DS2155 T1/E1/J1 Single-Chip Transceiver

REVISION A3 ERRATA

The errata listed below describe situations where DS2155 revision A3 components perform differently than expected or differently than described in the data sheet. Dallas Semiconductor intends to fix these errata in subsequent die revisions.

4. TRANSMIT FRACTIONAL SUPPORT

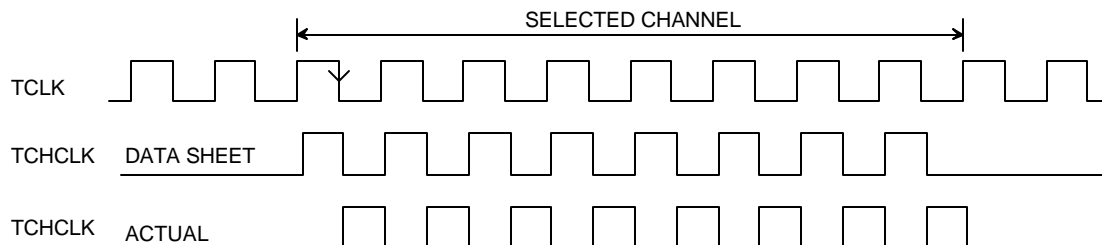
The transmit fractional support (alternate function of the TCHCLK pin) does not operate as described in the data sheet. Transmit data at the TSER pin is sampled on the falling edge of TCLK. In fractional support mode the TCHCLK pin should output a clock (gated version of TCLK) during a selected channel or channels. The rising edge of this clock could be used to present data to the TSER pin for sampling in the falling edge of TCLK. However, TCHCLK is delayed one-half clock in this rev of the DS2155. Its rising edge occurs AFTER the sampling time of the corresponding bit time of TCLK, as shown below.

There is no known software work around for this issue.

5. RECEIVE FRACTIONAL SUPPORT

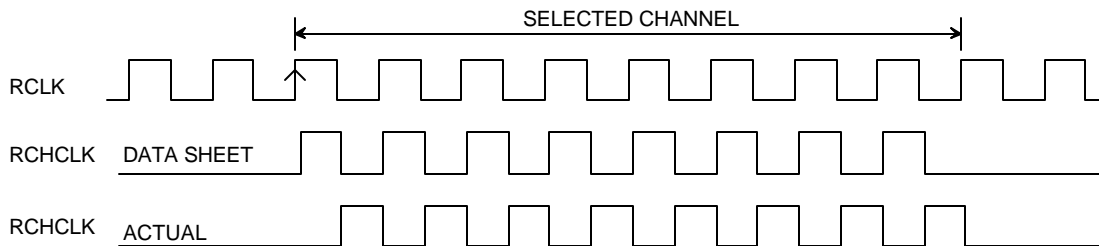
The receive fractional support (alternate function of the RCHCLK pin) does not operate as described in the data sheet. Receive data at the RSER pin is updated on the rising edge of RCLK. In fractional support mode the RCHCLK pin should output a clock (gated version of RCLK) during a selected channel or channels. The falling edge of this clock could be used by the backplane to sample data output on the RSER pin. However, RCHCLK is delayed one half clock in this rev of the DS2155.

As an alternate method, the backplane can use the rising edge RCHCLK to sample data output from RSER.
